Proposed Temporary Warehouse (excluding Dangerous Goods Godown) with Ancillary Facilities for a Period of 3 Years and Associated Filling of Land (Planning Application No. A/YL-KTN/1094)

1st Further Information - Responses to Departmental Comments

Attachment 1 - Response-to-Comments Table

2nd Further Information - Responses to Departmental Comments

drawing no.	rev.	scale
PLAN 7	—	N.T.S.

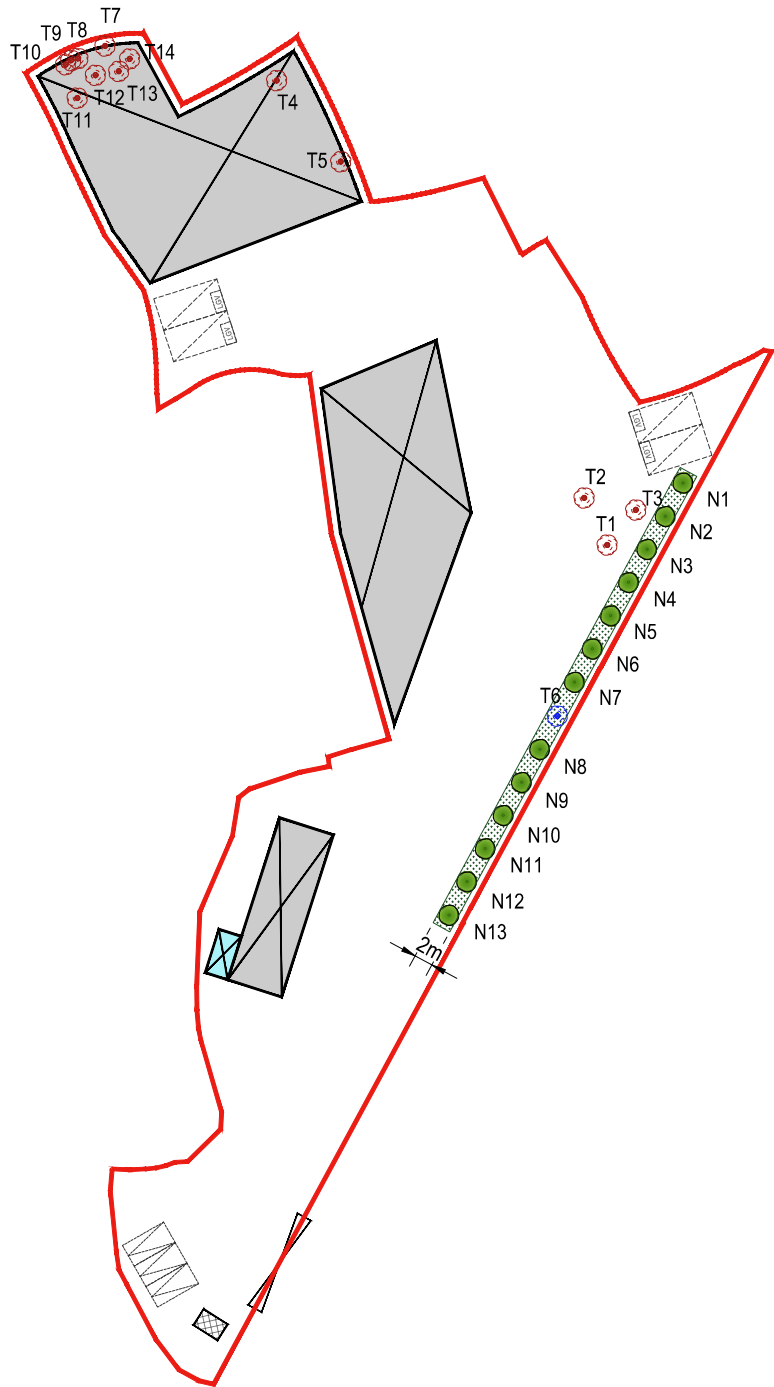
<p>to permit the structure(s) erected within Lot Nos. 907, 911, 912, 913 RP, 914, 960 RP, 961 RP, 962 RP and 967 RP all in D.D. 107. The application(s) for STW will be considered by the Government in its capacity as a landlord and there is no guarantee that it will be approved. The STW, if approved, will be subject to such terms and conditions including the payment of waiver fee and administrative fee as considered appropriate by LandsD. Besides, given the proposed use is temporary in nature, only erection of temporary structure(s) will be considered.</p>	
4	<p>Landscape Unit, PlanD (4.3.2025)</p> <p>According to the land filling plan (Plan 5), the Site is proposed to be filled wholly with concrete which may be in conflict with the existing trees. No tree information, proposed tree treatment and mitigation measures(s) are provided in the application.</p>	<p>According to the tree survey report (Appendix II) conducted on 14.3.2025, a total of 14 trees were record within the site. There is no Old and Valuable Trees (OVT) or protected species have been identified. Due to the site formation work for structures and circulation purpose, there are 13 of identified trees are proposed to be felled, one tree (T6) is proposed to be retained and 13 trees are proposed to be planted along the southeast boundary.</p> <p>A Landscape Proposal (Plan 7) is submitted by the applicant to provide landscape mitigation measures for the site. Along the southeast of site boundary, the applicant will plant 13 of new trees along the fencing within the site with spacing of about 4m and maintain properly. These new trees will create a more aesthetical pleasing visual experience for the nearby locals.</p>

NO. OF TREE WILL BE RETAINED : 1 (T6)
NO. OF TREE WILL FELLED : 13 (T1 TO T5, T7 TO T14)
NO. OF NEW TREE WILL BE PLANTED : 13 (N1 TO N13)
SPECIES OF NEW TREES : BRIDELIA TOMENTOSA
HEIGHT OF NEW TREES : NOT LESS THAN 2.75 m
SPACING OF NEW TREES : NOT LESS THAN 4 m
DIMENSION OF CONTINUOUS PLANTING STRIP: 2 m (W)

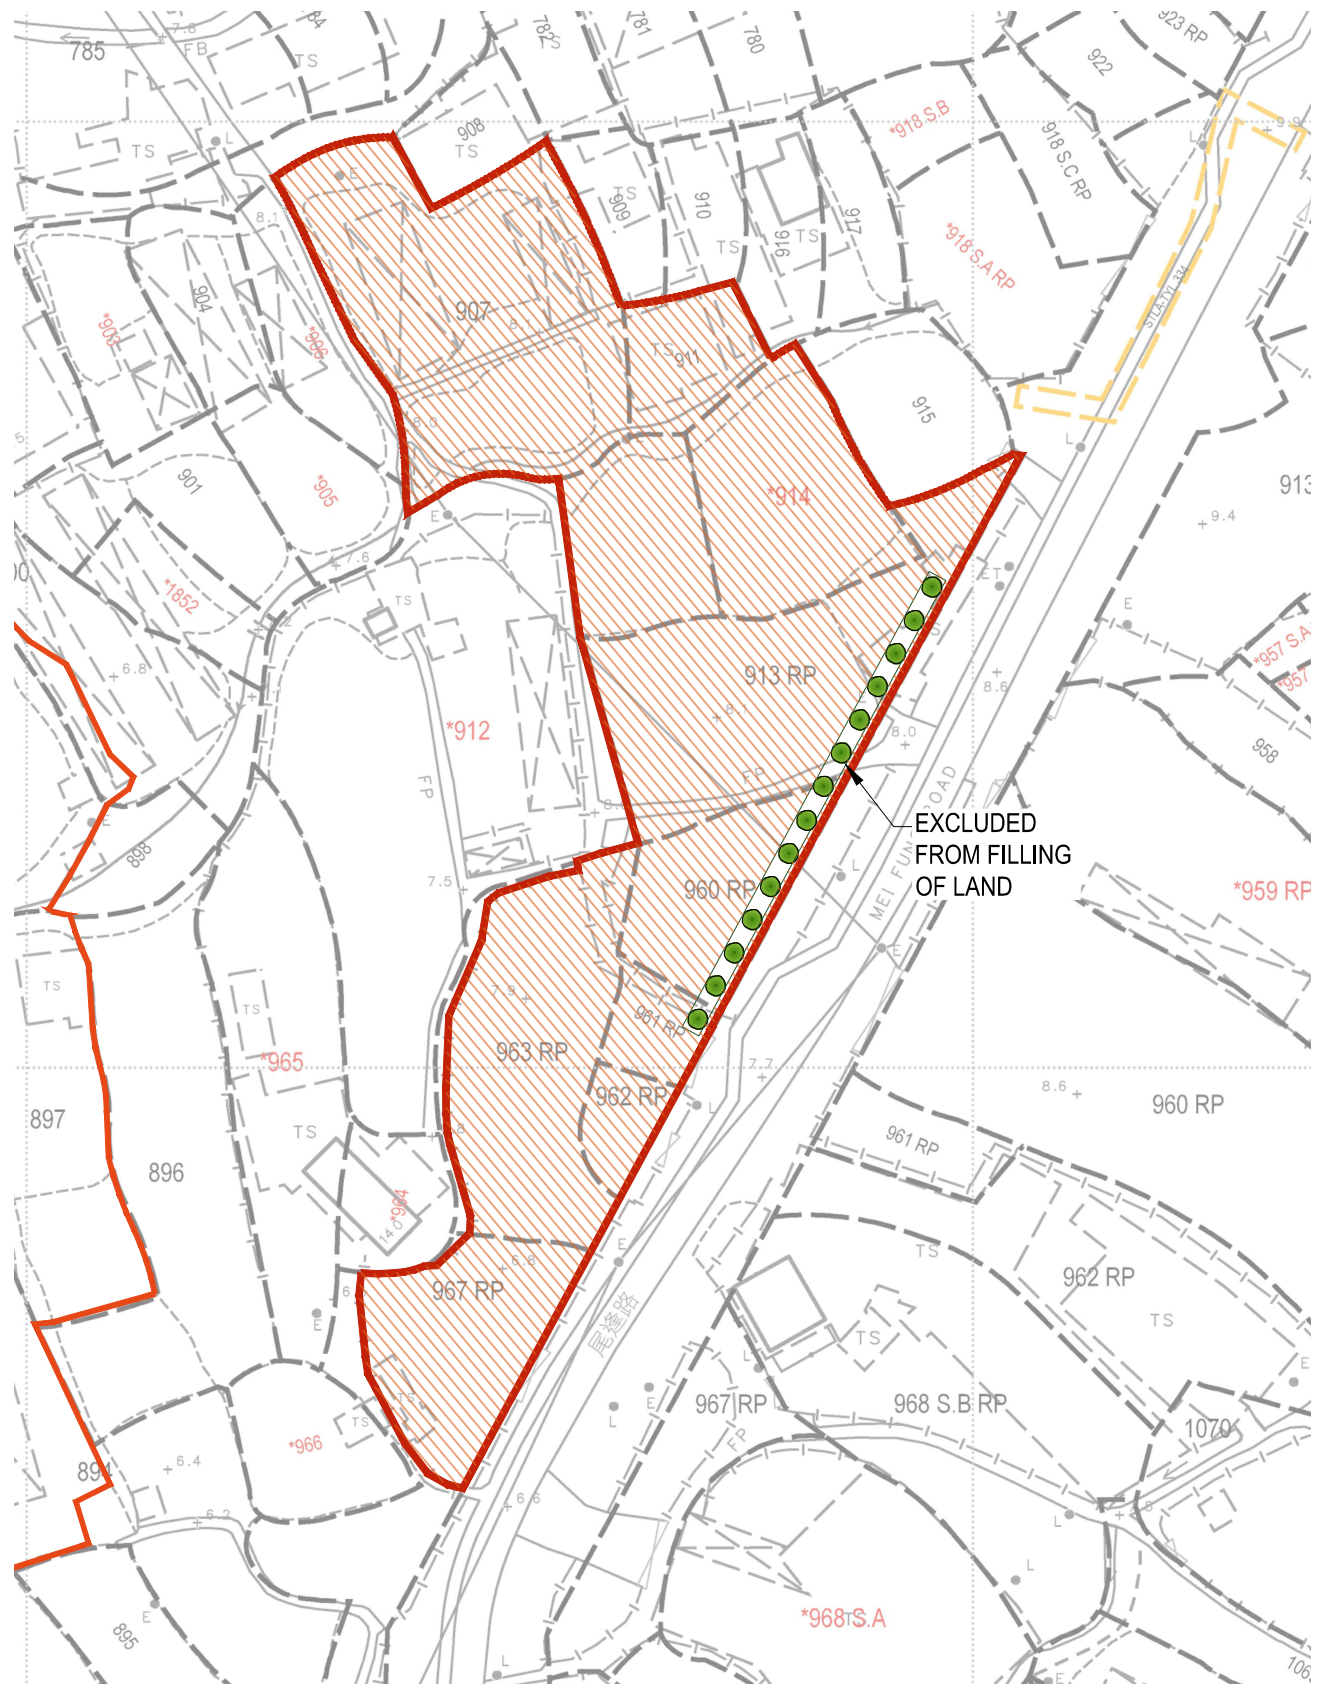
We refer to the tele-conversation with Ms Andrea Yan regarding Planning Department's comment on the filling of land matters, dated 22.5.2025, on the subject Planning Application.

The proposed continuous planting strip is excluded from filling of land (refer to the updated Plan 5). The proposed filling of land area is about 3904 m². We are pleased to submit herewith replacement pages of Planning Statement, Application Form and Plan 5 for your consideration.
